# POST OCCUPANCY EVALUATION

## HOBSONVILLE POINT SECONDARY SCHOOL HOBSONVILLE POINT, AUCKLAND

**June 2015**

Date: June 2015  
Reference: 1-46083.00  
Status: Ver 7

Figure 8 - View from first floor down into the cafeteria area

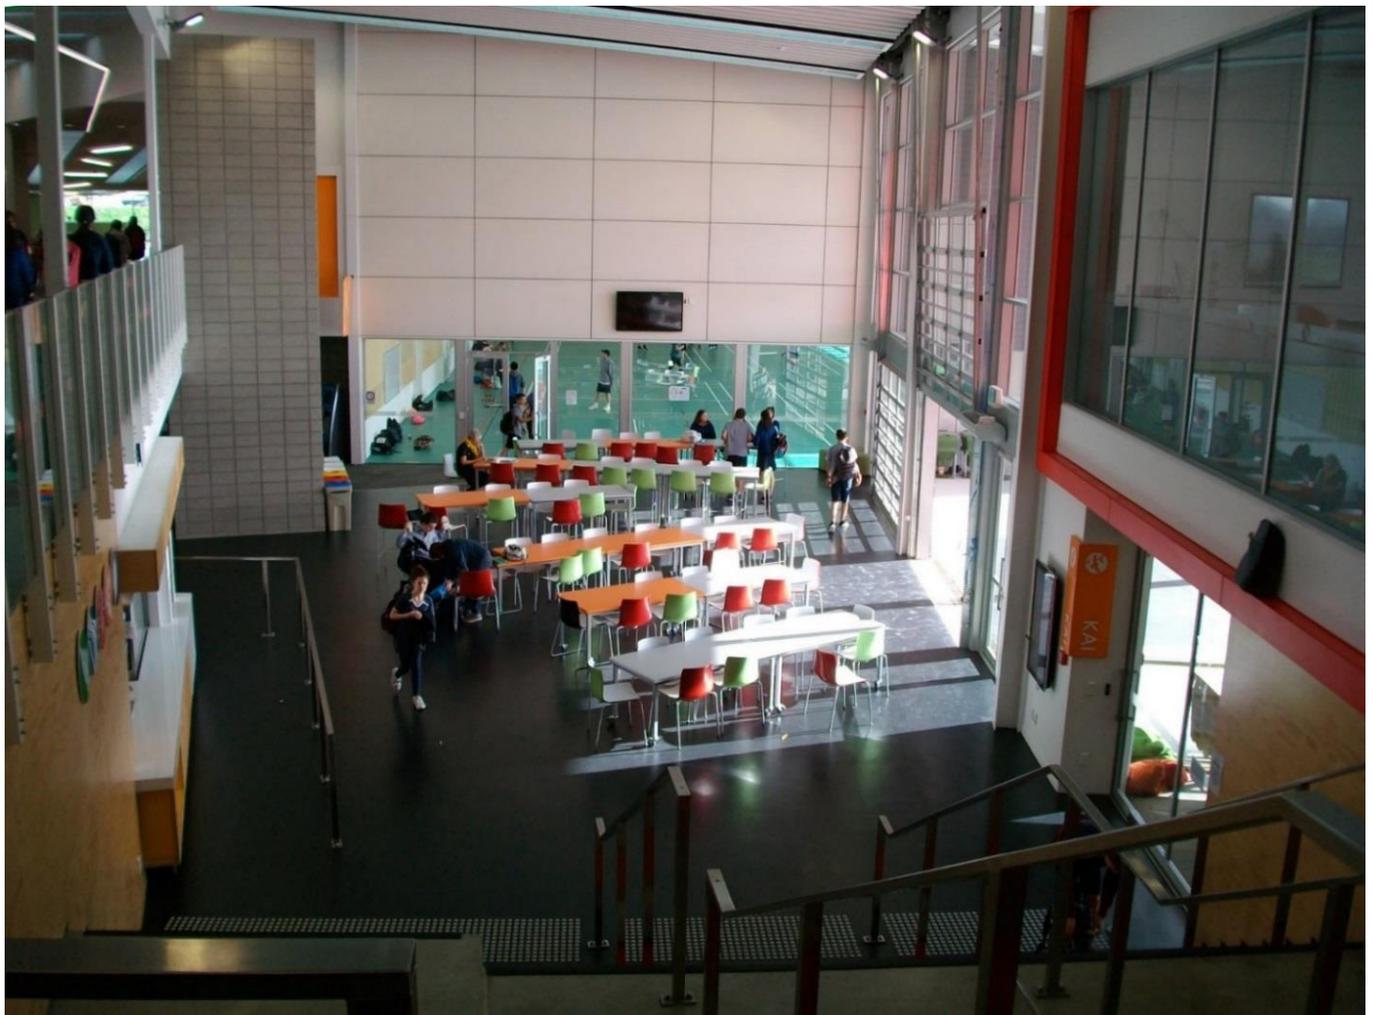
- The cafeteria seating area adjacent to the gymnasium is located within the central circulation area accessing the covered outdoor area and upper floor concourse.

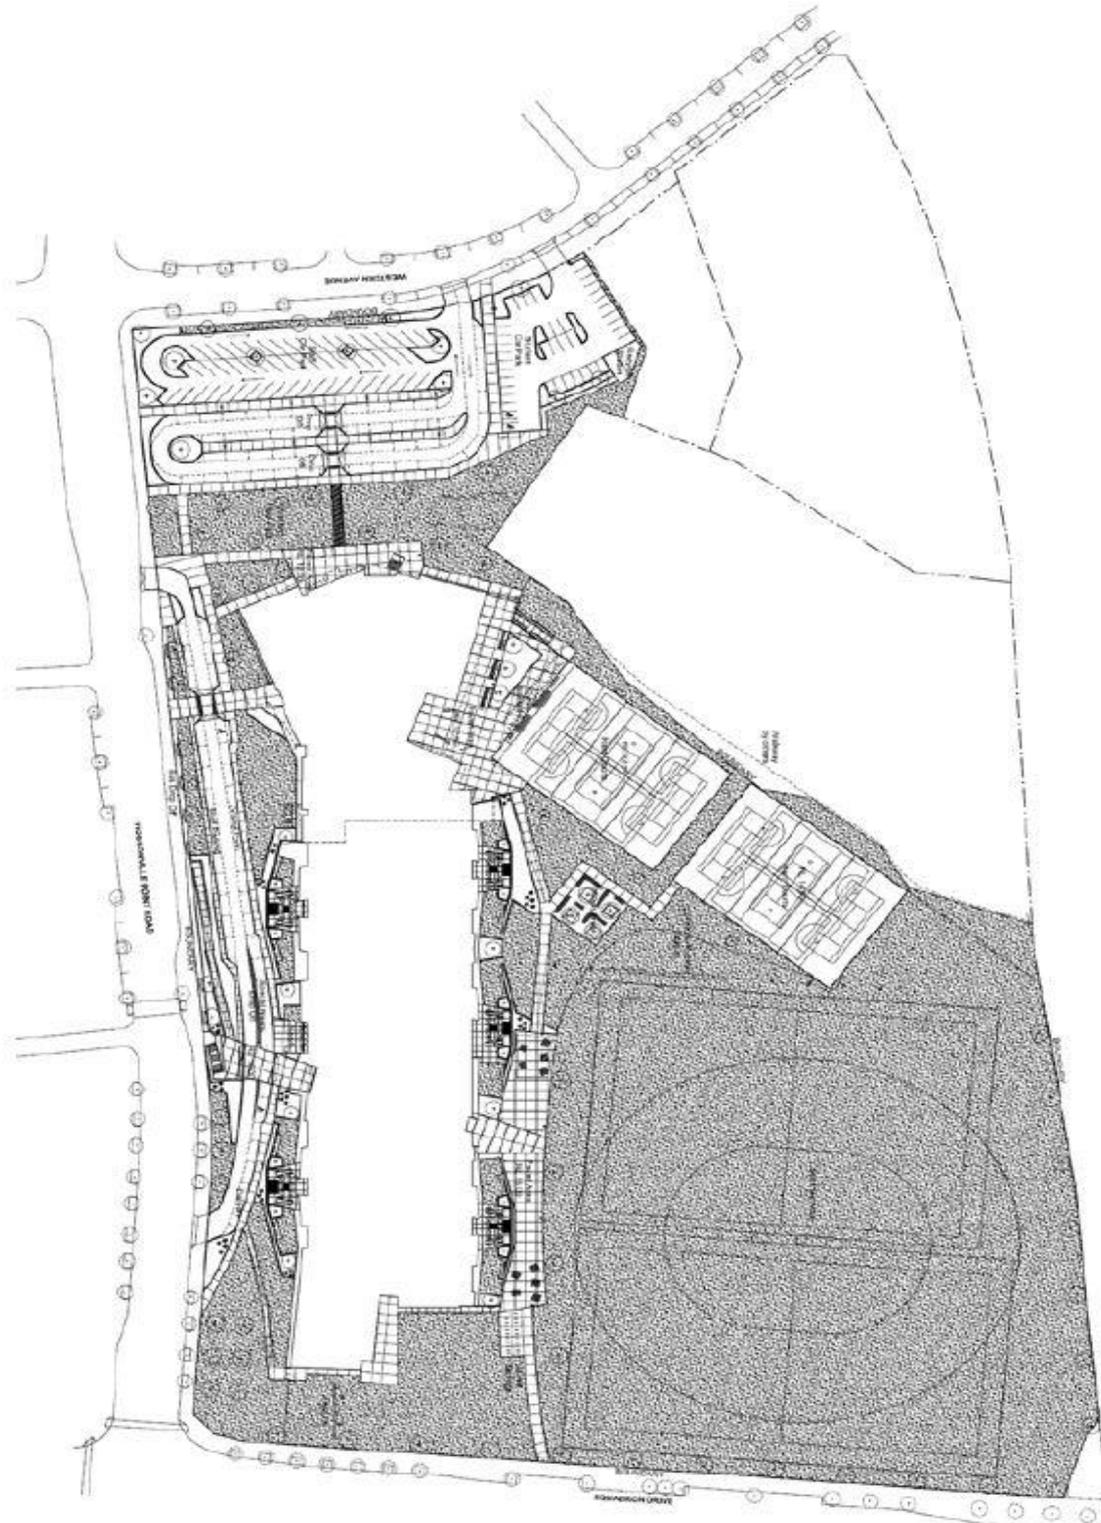
The sloping metal profile cladding presents hazards to occupants, especially at external corners that are lower than head height.

The exposed light fittings around the mirrors in the changing rooms are broken. Floor boxes are not secured and broken. Electrical shocks are reported in the Food Technology area, suspected lack of RCD protection or earth bonding to stainless steel sinks.

Modify the building to enhance safety for all occupants.
